Access Compliance Report

Public Rights-of-Way

(Curb Ramps)

Intersection ID: 13390	Main Street: W_KINGSTON_AV	Cross Street: WILMORE_DR	Location: SE
ADA ID: B2B9A064F104	Ramp Type: PerpDiag	Initial Pass/Fail: Fail	Overall Compliance: No
Severity Score: 12.5			
Codes/Mitigation Info/Possible Solution		Field Measurements/Component Compliance

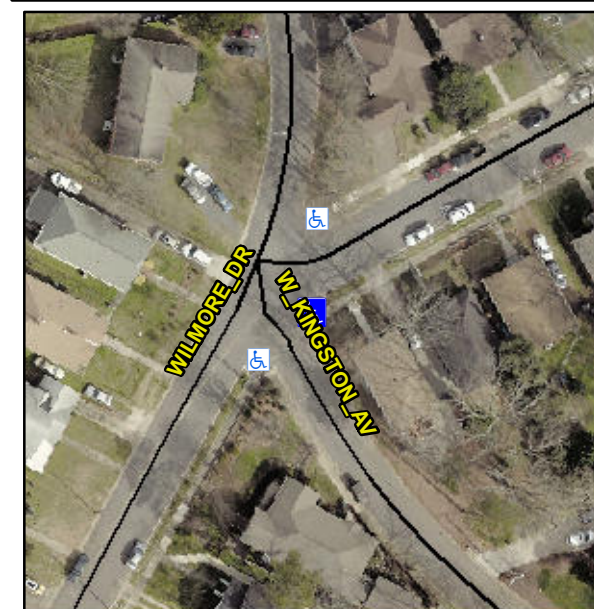
Not Found, R304.2.2

Compliance	Description	Data	Compliance	Description	Data
N/A	Ramp Length (in)	77.0	No	Ramp Slope (%)	9.8
Yes	Ramp Width (in)	48.0	Yes	Ramp XSlope (%)	1.6
N/A	Flare Type LT	N/A	N/A	Flare Type RT	N/A
N/A	Flare Slope LT (%)	N/A	N/A	Flare Slope RT (%)	N/A
N/A	Flare Traversable LT?	N/A	N/A	Flare Traversable RT?	N/A
N/A	Landing Length (in)	N/A	N/A	DWS Provided?	N/A
N/A	Landing Width (in)	N/A	N/A	DWS Contrast?	N/A
N/A	Landing Slope (%)	N/A	N/A	DWS Length (in)	N/A
N/A	Landing X Slope (%)	N/A	N/A	DWS Full Width?	N/A
N/A	Landing Curb? (Y/N)	N/A	N/A	DWS Offset (in)	N/A
N/A	Shared Landing?	N/A			
N/A	Gutter Ponding?	N/A	N/A	Gutter Slope (%)	N/A
N/A	Gutter Lip Ht (in)	1.0	N/A	Gutter X Slope (%)	N/A
N/A	Painted X Walk1?	No	N/A	Painted X Walk2?	No
	X Walk 1 Direction	To NE		X Walk 2 Direction	To SW
N/A	X Walk 1 Width (in)	N/A	N/A	X Walk 2 Width (in)	N/A
	X Walk 1 Slope (%)	9.1		X Walk 2 Slope (%)	3.4
	X Walk 1 X Slope (%)	1.4		X Walk 2 X Slope (%)	1.7

Remove & Replace Curb Ramp With Two New Directional Ramps or Equivalent.
